Office Action Summary

10/828,434

1. Restriction to one of the following inventions is required under 35 U.S.C. 121:
 - I. Claims 1-12 and 18-21, drawn to a ridge vent, classified in class 52, subclass 198.
 - II. Claims 13-17, drawn to a method of manually separating a ridge vent, classified in class 52, subclass 745.16.

**FIG. 3****FIG. 4**

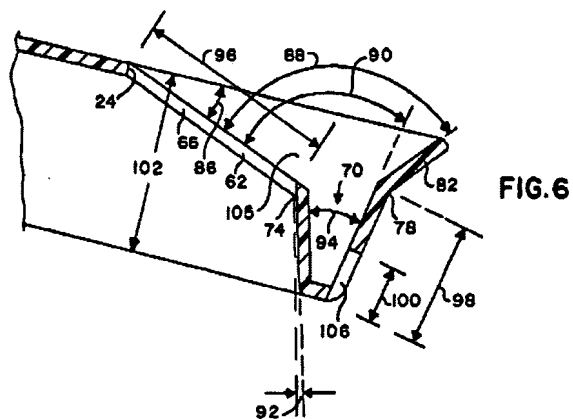
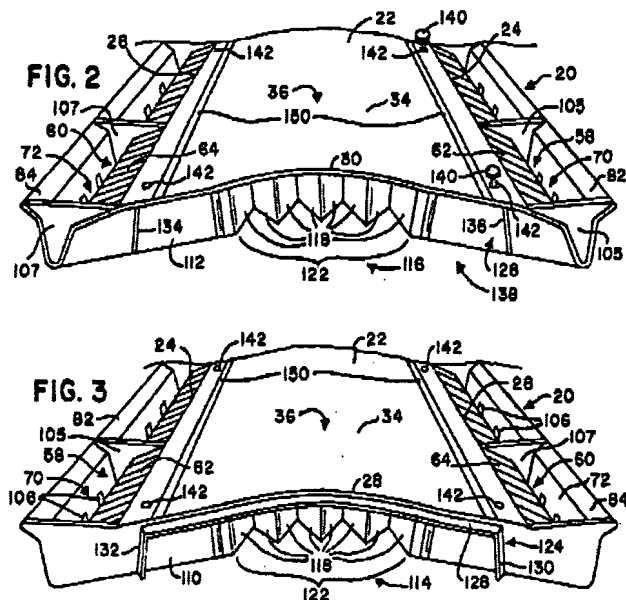
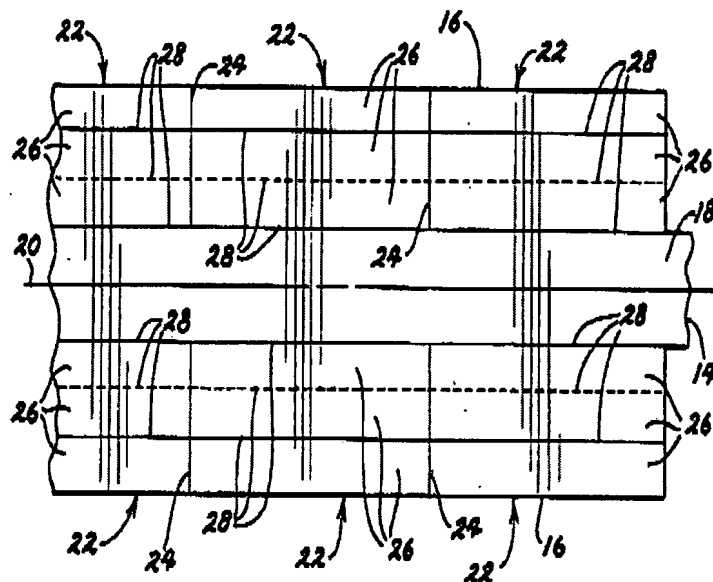
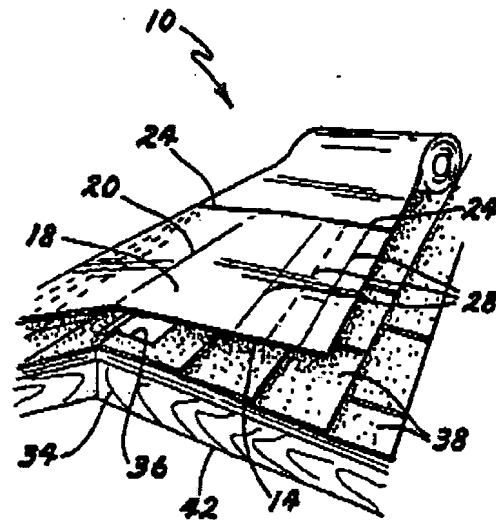
a. Claim 1. Smith discloses a ridge vent with an elongated flexible top panel (Column 2 Line 58) having a central portion 36 and edges 24 & 26 (Smith Fig. 2), wind baffles 82 & 84 defining an opening between the central section edges 24 & 26 and the baffles (See Figs. 2,3, & 6), and a plurality of ribs 66 spanning said openings between the edges and baffles. Morris discloses a ridge vent with at least one score line, disclosed as a "cut line" (Figs. 3 & 4 below, Ref. 24), extending across the top panel to "facilitate manual separation" along the line (Column 3 Line 9). The Morris score line is such because it is a notch, scratch, or incision, specifically a cut or perforation in the material. A score line is generally added because it allows an installer to easily and efficiently segment a ridge vent segment to a desired length. Thus, it would have been obvious to one having ordinary skill in the art, at the time the invention was made, to have modified the Smith ridge vent with the score line taught by Morris because it allows an installer to easily and efficiently segment a ridge vent segment to a desired length.

- b. Claim 2. The Smith/Morris combination discloses a plurality of score lines, referred to as "cut lines", 24 extending across the top panel 18 at spaced intervals in that each pair of segmented portions 22 are separated by a cut line resulting in a spaced plurality (Figs. Above).

h. Claim 10. The Smith/Morris combination discloses all the elements of the invention including wherein the aligned cutting guide is formed in each wind baffle. The Smith/Morris combination discloses a cut line "extending entirely through the blank," (Morris Column 3 Line 11, See also Figs. 3 & 4).
